Re: Docket No. 461A - CSC 461A Greenwich Substation and Line Project - Petition for Reconsideration

Response to TOWN-02 Interrogatories dated 08/11/2017 TOWN-077-SP01

CL&P dba Eversource Energy Docket No. 461A Data Request TOWN-02 Dated: 08/11/2017 Q-TOWN-077-SP01 Page 1 of 1

Peak 24-Hour Loads for the 4 Parallel Feeders for Previous 3 Years

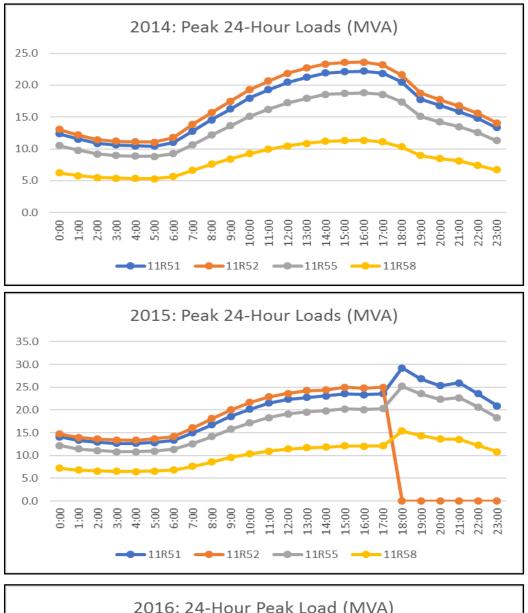
For each year since 2010, quantify the distribution of the actual peak load (in MVA) among the feeders identified in Eversource's Response to Q-TOWN-001 by completing the spreadsheet attached hereto as Exhibit 77 entitled "Peak Load Distribution on 27.6-kV Feeders —Greenwich."

Pursuant to the Chairman's resolution of the Applicant's prior objection to this question at the August 29, 2017 evidentiary hearing, the Applicant provides attached the loads on each of the four feeders from Cos Cob Substation serving the Prospect Substation (11R51, 11R52, 11R55, and 11R58) on the peak load days experienced in 2014, 2015, and 2016. The load on each cable on each day is shown on a 24-hour graph. Please note that at 17:00 hours on the 2015 peak day (July 20), the 11R52 feeder experienced a fault (as stated in the response to Q-OCC-042 in Docket 461), so that the load on that cable was automatically transferred to other cables emanating from the Cos Cob Substation, including the 11R51, 11R55, and 11R58 cables.
